## **TOPSwitch-HX™ PRODUCT CHANGE NOTIFICATION**

Control No. PCN-09301

July 17, 2009

Figure 1: Example of a current marking format.

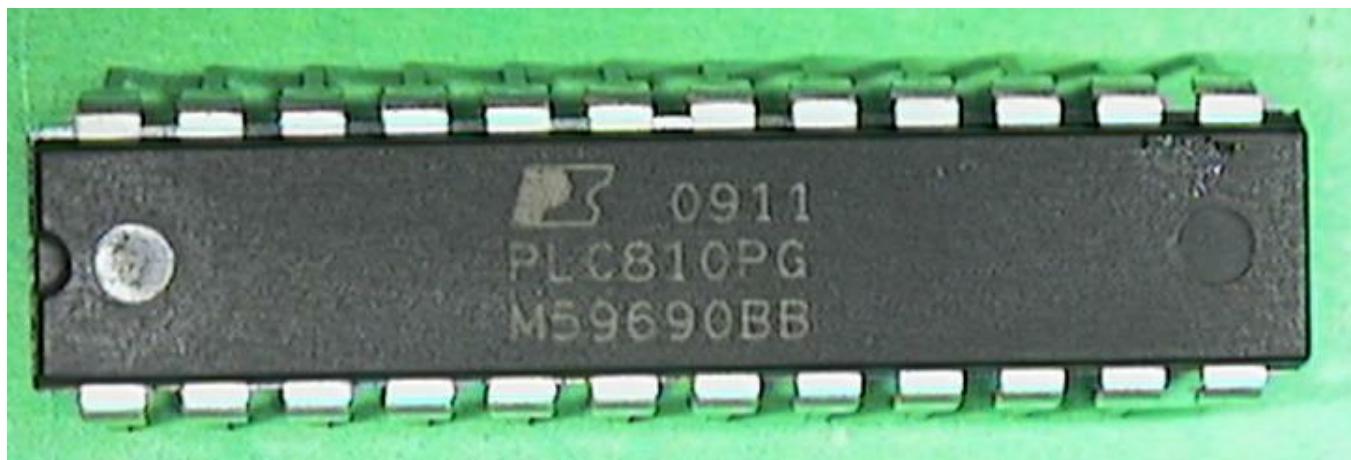
Current Format: Currently the first line consists of a letter followed by three digits to indicate the date code. The current date code format is as follows.

Letter - Digit 1 – Digit 2 – Digit 3. Example: M841 means week 41 of year 2008 at assembly site M. Please see Figure 1 on page 2.

Letter indicates the assembly location; digit 1 is the last digit of the year, digits 2 and 3 indicate the week.

New Format: The new date code will consist of four digits as follows.

Digit 1 – Digit 2 – Digit 3 – Digit 4. Example: 0911 means week 11 of year 2009. Please see Figure 2 on page 2. (The example is for a new part type that adopted the new format when released).

Digits 1 and 2 will indicate the last two digits of the year; digits 3 and 4 will indicate the week.
